Well Name: SEINFELD FEDERAL UNIT MULVA	Well Location: T24S / R35E / SEC 27 / SWSW /	County or Parish/State:
Well Number: 222H	Type of Well: OIL WELL	Allottee or Tribe Name:
Lease Number: NMNM138893	Unit or CA Name:	Unit or CA Number: NMNM141169X
US Well Number: 3002550893	Well Status: Approved Application for Permit to Drill	Operator: TAP ROCK OPERATING LLC

Notice of Intent

Sundry ID: 2725369

Type of Submission: Notice of Intent	Type of Action: APD Change
Date Sundry Submitted: 04/12/2023	Time Sundry Submitted: 11:31
Date proposed operation will begin: 04/12/2023

WELL LOCATION AND ACREAGE DEDICATION PLAT

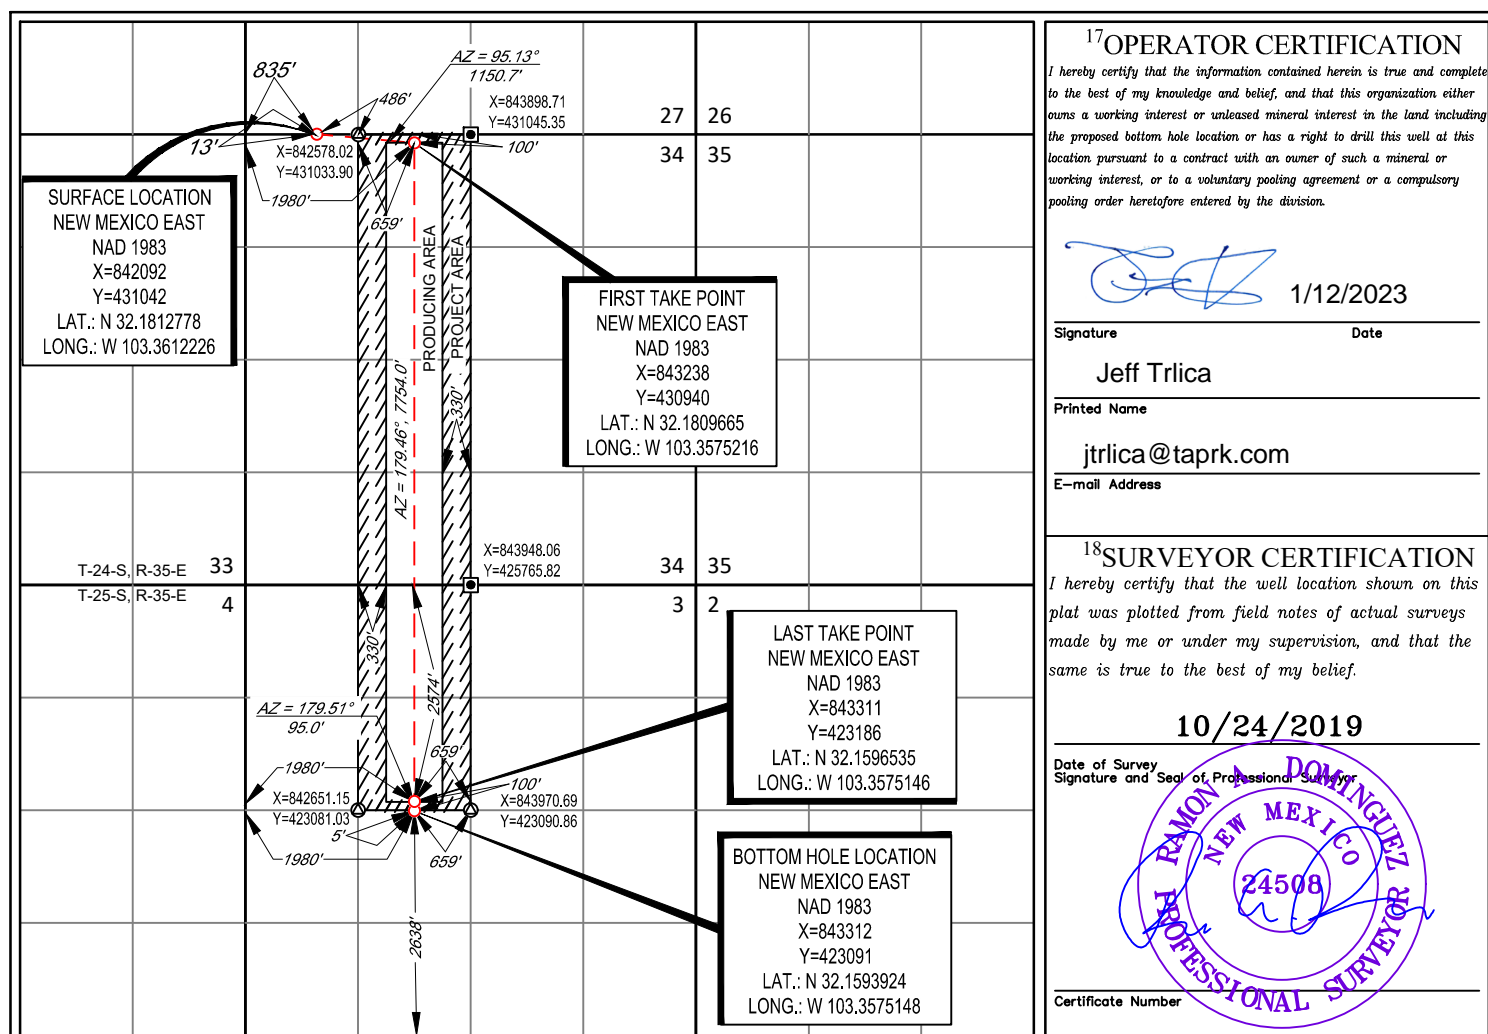
Procedure Description: For the referenced well, Tap Rock requests: 1. To change the referenced well name from Mulva Fed Com 222H to: Seinfeld Federal Unit Mulva 222H. See attached updated C-102. 2. To change modify OH size and casing/cement design. See attached casing, cement, and mud tables.
